20 June 2021

AQUATIC ASSESSMENT OPINION HIGHLANDS CENTRAL WIND ENERGY FACILITY (WEF): PROPOSED AMENDMENTS TO THE ENVIRONMENTAL AUTHORISATION (DEFF REF: 14/12/16/3/3/1/1958)

FIGURE 1: Amended project layout (blue lines), when compared to the observed watercourses with 32m buffer.

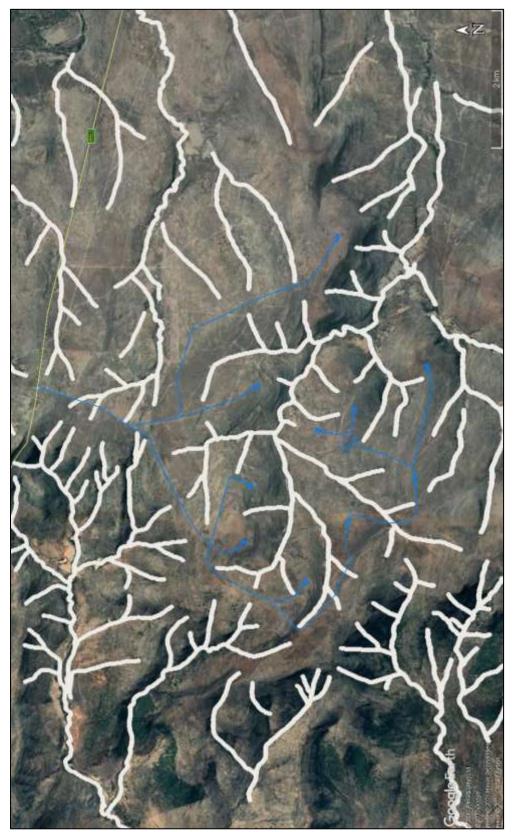
Table 2, summarises the findings of the impact assessment comparison between the authorised and amendment layout (Figure 1). As the impacts and their significance (with and without mitigation) were similar the reversibility, irreplaceability, extent, duration, severity, probability and status also remains unchanged, thus Table 2 only indicates the overall significance.

The proposed increased size of the turbines and increased footprint (of the turbine foundations and hardstandings) has had no direct impact on the aquatic environment, as the overall changes are mostly vertical (increases in height), which necessitated a change in the road layout (due to the reduction in the number of turbines), but more importantly the positions and changes to the associated infrastructure still avoid the most sensitive areas of the delineated aquatic zones including their respective buffers. This includes the proposed Battery Energy Storage System.

In conclusion, the potential impact of the proposed amendments and amended layout on the aquatic environment will remain unchanged from the original impact assessment if all the proposed mitigations are upheld. There is however an overall advantage to the proposed layout as the overall number of watercourse crossing has been reduced, although the impact significance would remain LOW for all the impacts.

Thus, based on the findings of this study, no objection to the authorisation of any of the proposed amendments, assuming that all mitigations proposed in the reports submitted are carried out. Similarly, in the assessment of potential cumulative impacts, no additional impacts or changes to the previously assessed impacts would be required due to the proposed amendments.

No changes to the original mitigations or EMPr considerations are required.
